City of Lake Elmo Planning Department
OP Development / Concept Plan Review

From: Ben Gozola, City Planner

Meeting Date: February 22, 2016

Applicants: Landucci Homes

Soils Map

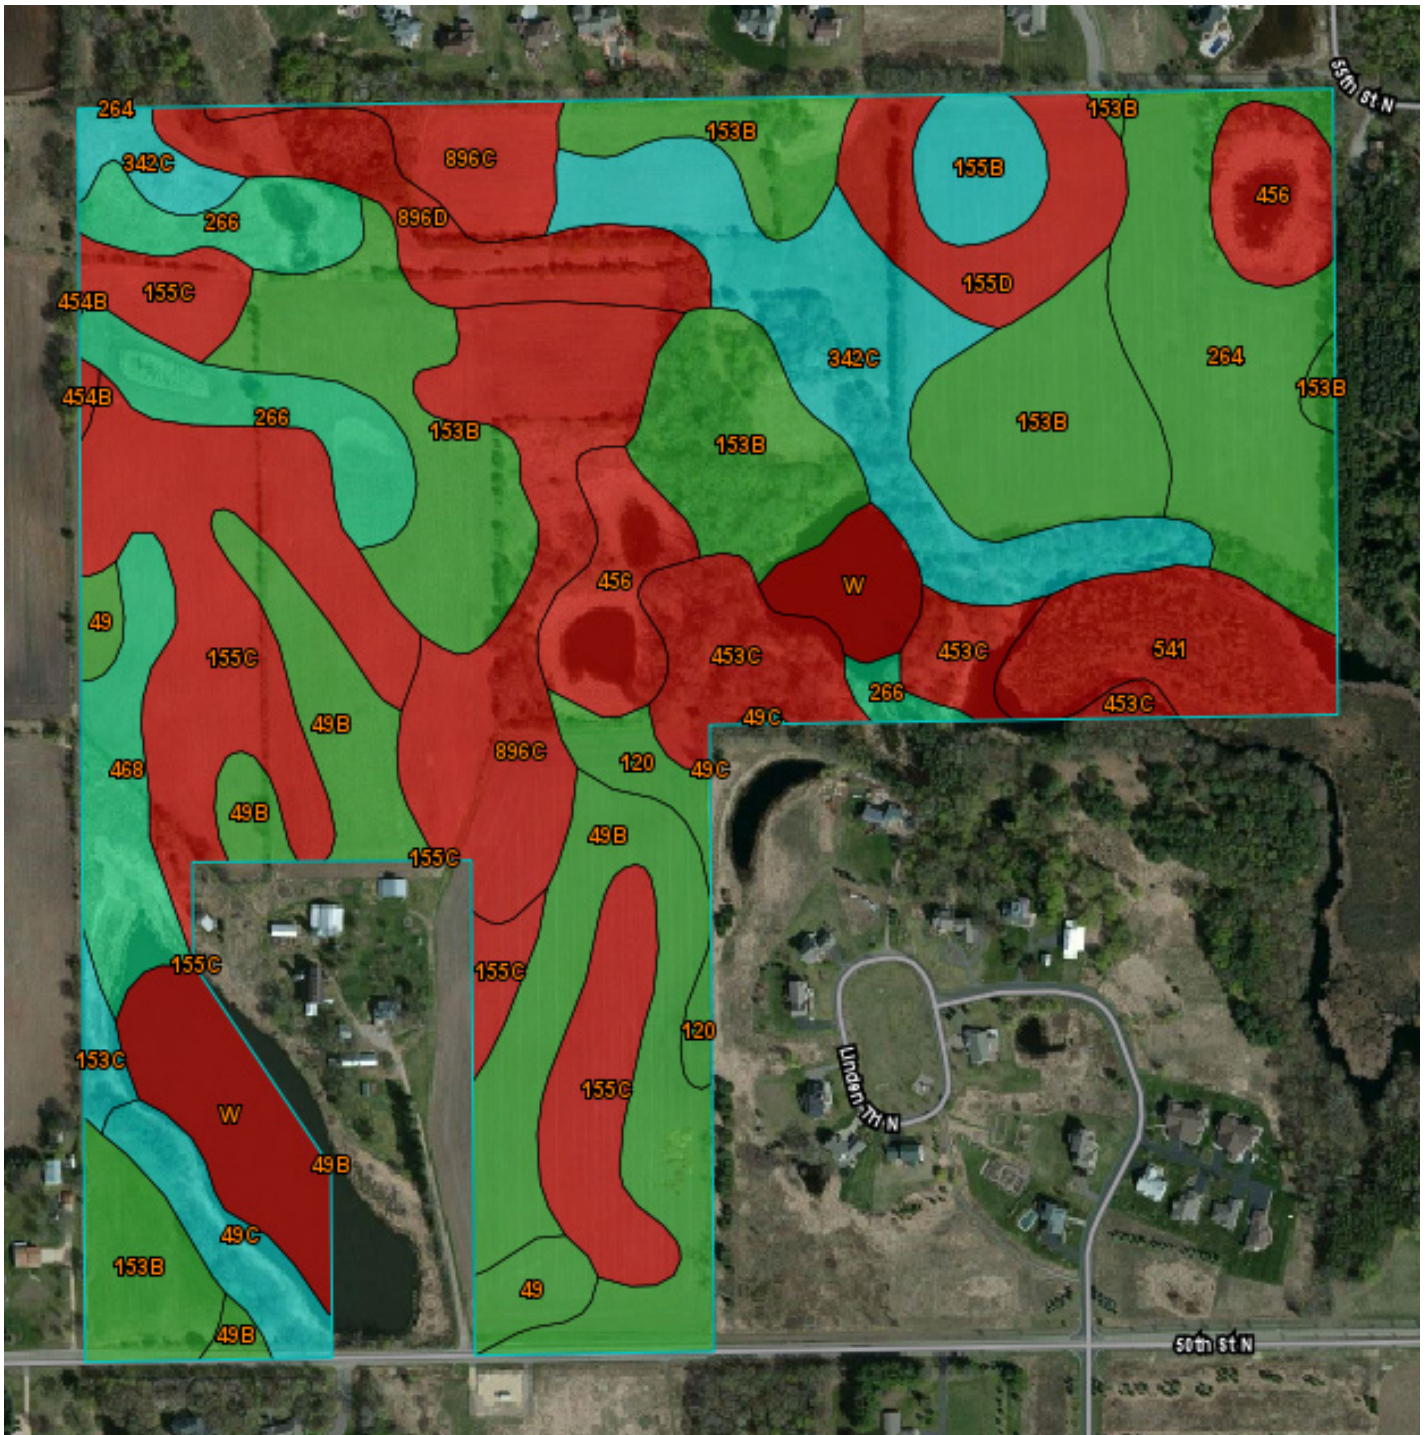
Staff comment: Please see the soils data and maps on the following pages.

On the priority list of things to accomplish with lot design, placing homes “on the least fertile soils for agricultural uses and in a manner which maximizes the usable area remaining for such agricultural use” is the 2nd highest priority, and many of these lots (especially in the NE corner) are located on prime farmland.

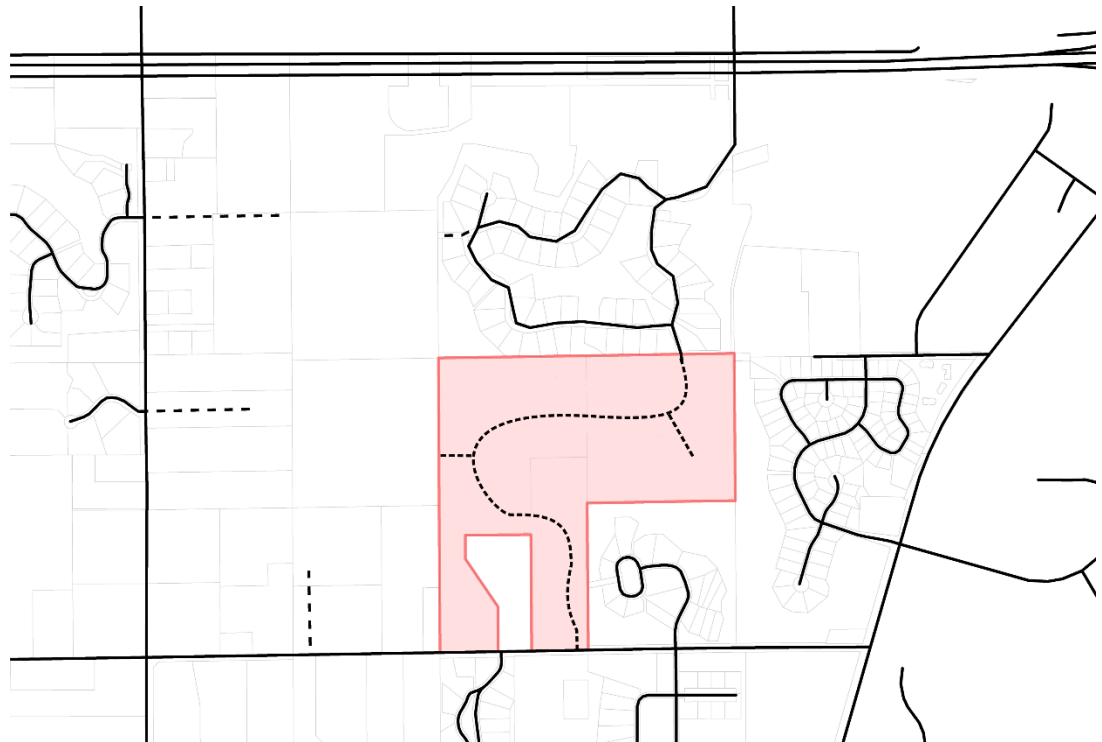
Staff Comments: As indicated in the staff reports on previous concept plans, a critical pedestrian connection that will be required by the City is the construction of a bituminous trail on the north side of 50th Street connecting the two sides of Outlot C and extending to the westerly limits of the Plat. This connection must be shown on any future preliminary application. Other than that, the requirements for pathways appear to be met by the proposed plans. **Criteria met.**
